Response to Request for Review

‘Using off gas cogeneration project in PT KPP’

(Ref. 9327)

<Diagram 1. Relationship between PT. Krakatau Poscopower and PT. Krakatau Posco >

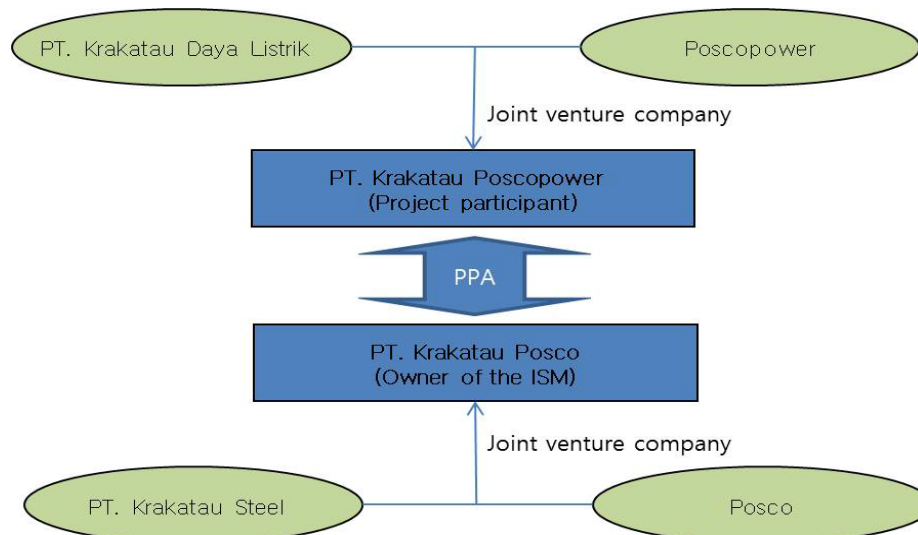
- 1. The DOE shall further substantiate how it has validated the suitability of input values, in particular the waste gas tariff (6.08 cent/KWh) considering it appears to be an internal price for the waste gas between the owner of the project activity (PT. Krakatau Poscopower) and the owner of the project facility (PT. Krakatau Posco). In doing so, the DOE shall also explained how it has validated the relationship among the owner of the project activity (PT. Krakatau Poscopower), PT. Krakatau Daya Listrik, the owner of the project facility (PT. Krakatau Posco) and PT. Krakatau Steel. Please refer to EB 60, paragraph 93.**

The relationship between PT. Krakatau Poscopower (PP) and PT. Krakatau Posco (owner of the ISM) is defined as below diagram.

PT. Krakatau Poscopower (PP) was established as a joint venture company among PT. Krakatau Daya Listrik and Poscopower. And PT. Krakatau Posco (Owner of the ISM) was established as a joint venture company among PT. Krakatau Steel and Posco respectively.

<Figure 1. Boundary for baseline emission of the project >

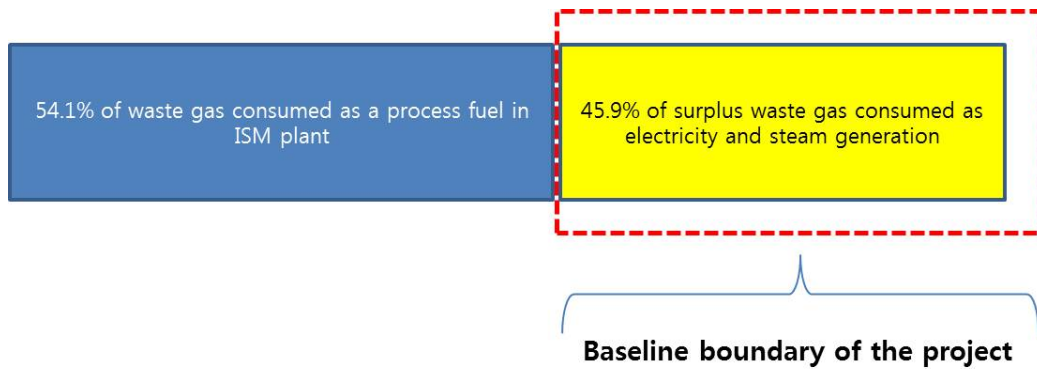
- 2. The DOE shall further substantiate how it has validated the extent of use of waste gas from the greenfield waste energy generation facility (project facility), given the fact that the alternative designs identified and analyzed under option 2 of Annex 1 are for the project activity rather than the project facility whereas the applied methodology requires the assessment of alternative design of the project facility. Please refer to ACM0012 version 4, Annex 1, option 2.**

Before analysing the extent of use of waste gas, we would like to define a boundary for baseline emission such as a scope of waste gas use by waste energy generation facility of the project activity. A number of iron and steel production processes such as Blast Furnace, Coke Oven, Plant Plate Mill etc. must consume the waste gas as a process fuel in given priority and then surplus waste gas will be recovered and used for cogeneration such as project activity. Therefore, PP defined boundary for baseline emission as surplus waste gas that will be recovered and used for cogeneration.

We analyzed extent of use of waste gas only for the surplus waste gas after using waste gas at iron and steel production processes. It was confirmed through energy balance in FSR and detail amount of waste gas production and consumption with the validity was explained below No. 3 of this report.
